1. Crane-France Subdivision; KPB File 2024-099

CRANE-FRANCE SUBDIVISION REPLAT 2024

# ITEM #1 - PRELIMINARY PLAT CRANE-FRANCE SUBDIVISION REPLAT 2024

KPB File No.	4. 2024-099
Plat Committee Meeting:	October 14, 2024
Applicant / Owner:	Alan R. & Jo Ann Crane
Surveyor:	Jason Schollenberg – Peninsula Surveying, Inc
General Location:	Forest Lane, Mile 28 Kenai River, Sterling Area

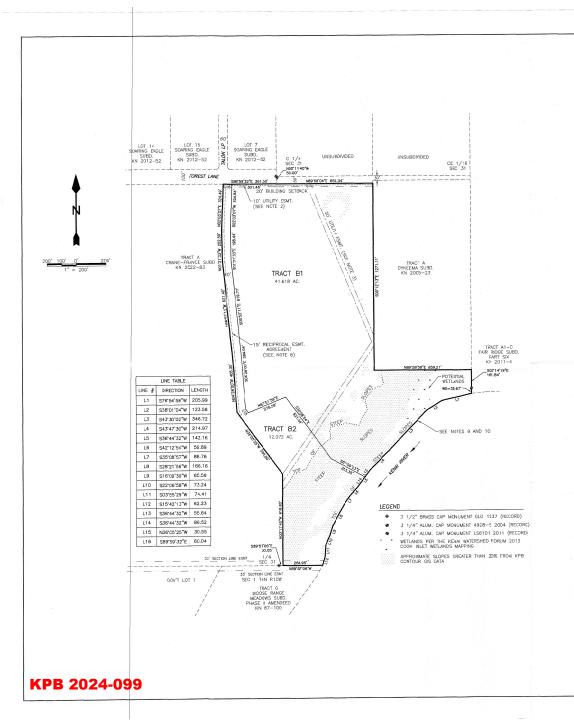
The block length is non-compliant. An exception to KPB 20.30.170, Block Length, was granted by the Plat Committee at the meeting of August 8, 2022 for Parent Plat KN 2022-83. This exception is being carried forward as plat note number fourteen. **Staff recommends:** the plat committee concur this exception shall be carried forward and can remain on the plat as noted.

Tract B2 is a flag lot with the access portion being 60-feet wide connecting to Forest Lane. No exception for KPB 20.30.190 (B) is needed. **Staff recommends:** Add standard note on the plat for flag lot: "No structures are permitted within the panhandle portion of the flag lot." And to add a note that "Flag lot neck is not intended to be considered as a road for use or dedication."

The River Center Review identified the plat to be within a FEMA flood hazard zone and Floodway. The required Flood Hazard note is on the drawing but the updated flood zones should be added to the note with the effective date. **Staff recommends:** depict on the plat the new AE zone and Floodway as requested by the River Center Review. Add Floodway Notice per KPB 20.30.280 (E).

The River Center Review identified portions of the plat to be within the Anadromous Waters Habitat Protection District. The required plat note is added to the preliminary plat as plat note number ten. **Staff recommends:** correct note to reflect note as stated in KPB 20.30.290.

o Correct KPB File Number to: 2024-099

- Update the Plat Approval date to: October 14, 2024
- Review Certificate to Plat Item Number 11 and add to plat, if applicable.

Label sections to the east and west.

Correct subdivision names to the east and south of proposed plat: <u>"Dykema"</u> Subdivision, KN 2005-23" and "Moose Range Meadows Subdivision Phase II <u>Amended</u>, KN 87-100"

**Staff recommendation**: place the standard note on the plat for the flag lot(s): No structures are permitted within the panhandle portion of the flag lot(s).

Any area of the subdivision within the floodplain, floodway or Seward Mapped Flood Data Area (SMFDA) is to be shown and labeled on the plat.
